CONTRACT CHANGE ORDER NO. ____
SHEET ___ OF ___

SAN FRANCISCO OAKLAND BAY BRIDGE
EAST SPAN SEISMIC SAFETY PROJECT

YBI TRANSITION STRUCTURES - HINGE K

HINGE K CLOSURE DETAILS NO. 1

PLAN
1:80

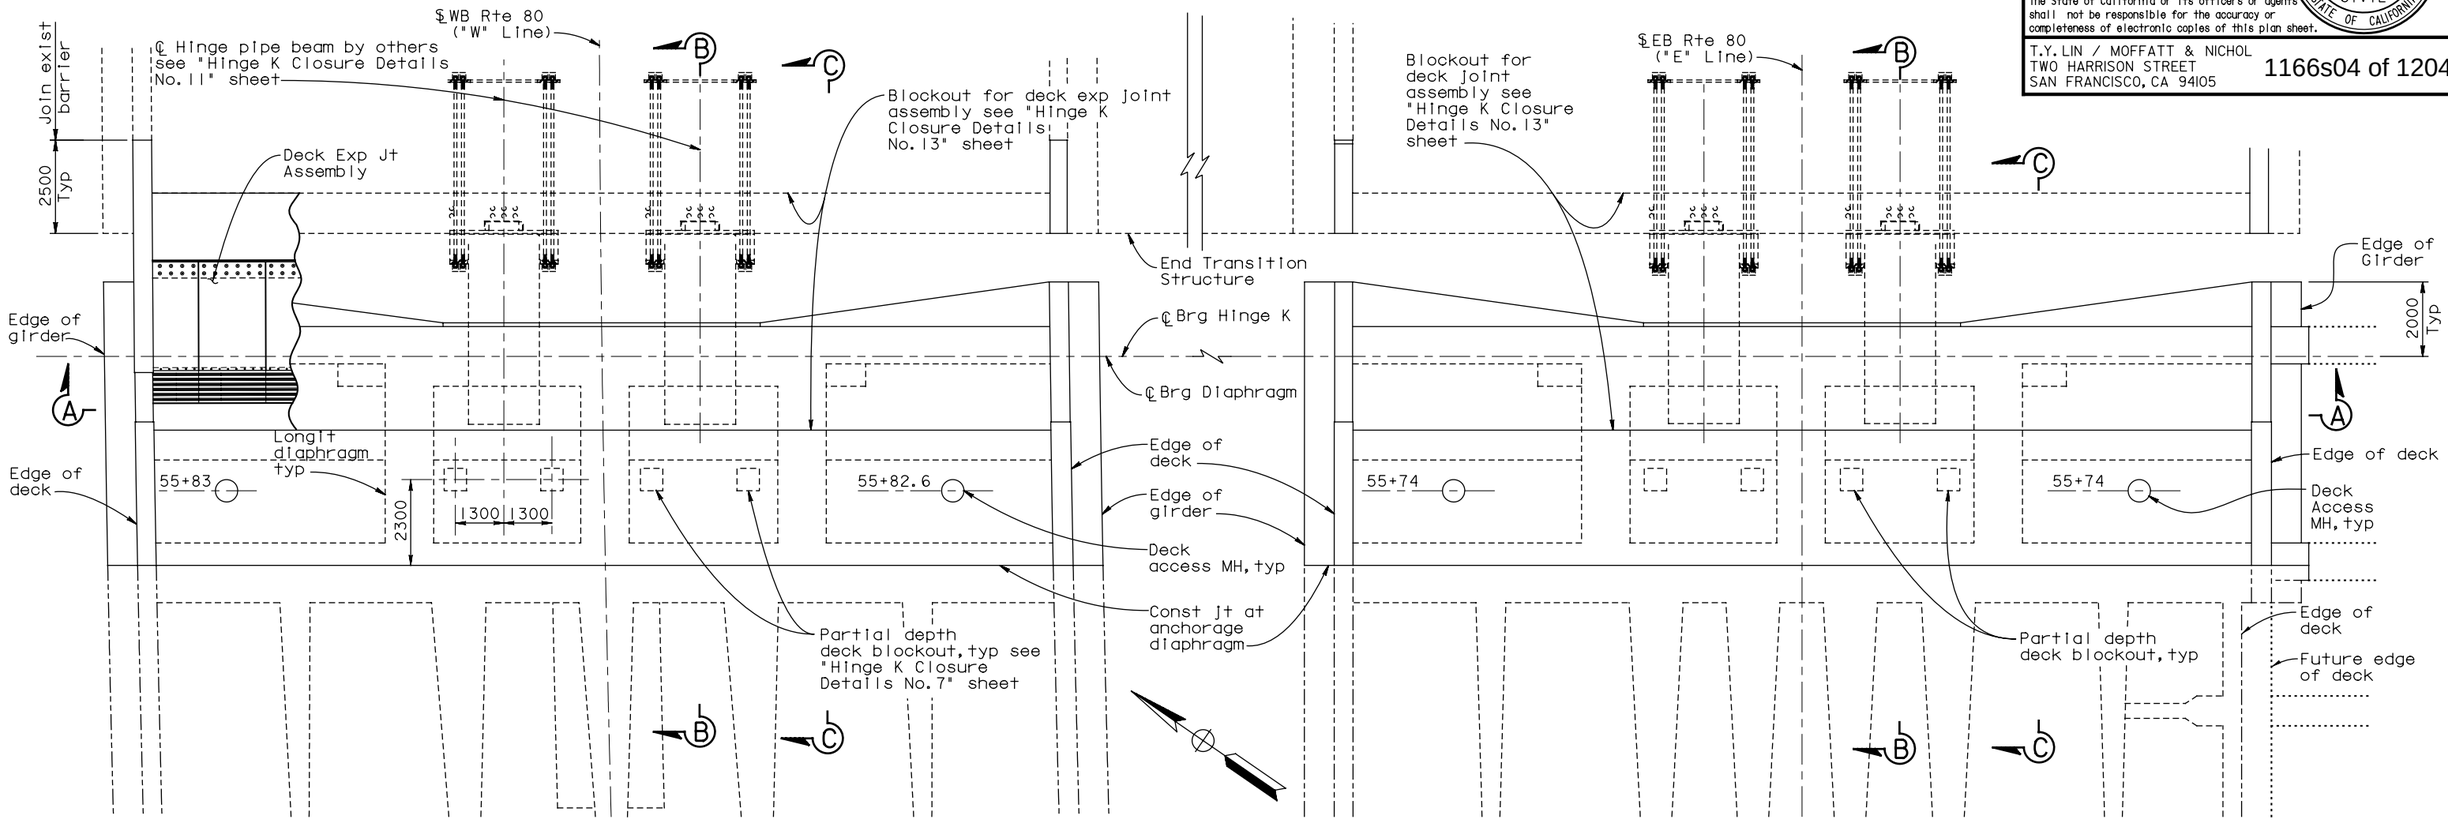
Notes:
- Hinge K closure pour not to be placed until a min of 75 days after prestressing adjacent frame.
- At EB structure, bike path counterweight shall be placed prior to placement of Hinge K closure pour.
- Prior to placement of Hinge K closure concrete, counterweights shall be placed at the cantilever ends of the adjacent frames to balance a portion of the dead load reaction of the closure concrete (approx 13 300 KN). Center of gravity of counterweight to be located at station line for WB Structure and 625 mm south of station line for EB Structure. Counterweights to be removed after closure concrete has attained required strength and prior to falsework release.
- Concrete ballast within Hinge K closure shall be placed after Hinge K bearing assembly is grouted in final position.
